Product Change Notification

Change Notification #: 112550 - 00

Change Title: Intel® Desktop Board DB85FL, Boxed & Bulk
PCN 112550-00, Product Material
Change Slot Connector

Date of Publication: August 29, 2013

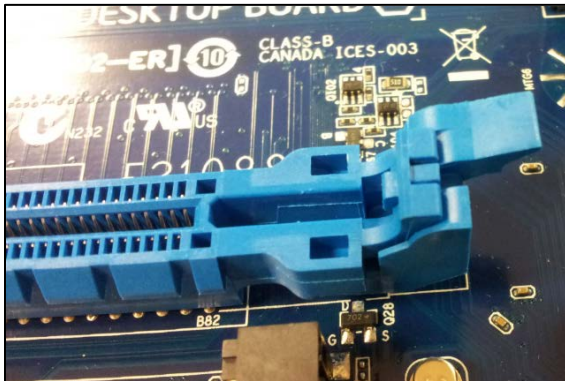
Intel will be changing the slot connector on the Intel® Desktop Board DB85FL to LOTES PCIEx16. See images below:

This change has been thoroughly evaluated to ensure there is no quality, reliability, or functional implication to our customers, but Intel has noted that the effort (force) needed to seat or eject the card may vary between connectors. Intel is not recommending additional qualification of these changes on platforms received from Intel.
